From: Ritesh Parekh <riteshparekh@hotmail.co.uk>
Sent: 21 July 2025 12:08
To: Ashleigh Gade
Subject: Re: 25/00227/FUL - Unit 1 Automatic Engineers Burbage Road Burbage - Request for Information
Attachments: 5107-200Rev B Planning Drawing_Planning.pdf
Importance: High

I write with regard to planning application 25/00227/FUL for a change of use to car wash, erection of canopies and associated external works (retrospective) at Unit 1, Automatic Engineers, Burbage Road, Burbage.

Details:	Retrospective Application Approval of Erected Canopies, Car Wash Use And Associated external works including concrete hard surface
----------	--

Scale: 1:100 & as noted @ A1	Date: Feb 2025	Drp No: 5107-200Rev B
---------------------------------	-------------------	--------------------------

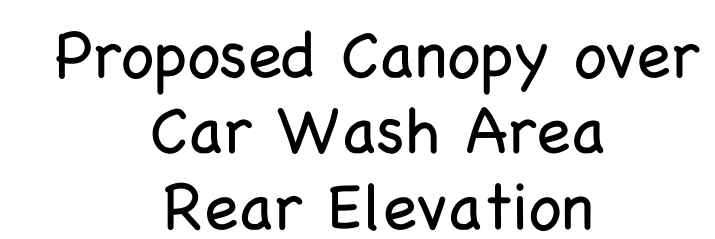
7. Amended Elevations and/or Site Plans for the vacuum/drying canopy that:
 - a. Show the area(s) to the rear of the lean-to that appear to be partially clad, including confirmation as to whether any of these areas to be fully enclosed.
 - b. Show the dimensions and shape of the canopy and associated lean-to consistently. The current layout and dimensions of the structure do not currently match between the Site Plan and Elevations.

7. a) The canopies will have roof and won't be enclosed, updated Planning Drawing 5107-200Rev B attached for more information.
b)

Rev B - Canopy photos added
Rev A - Redline highlighted in Red
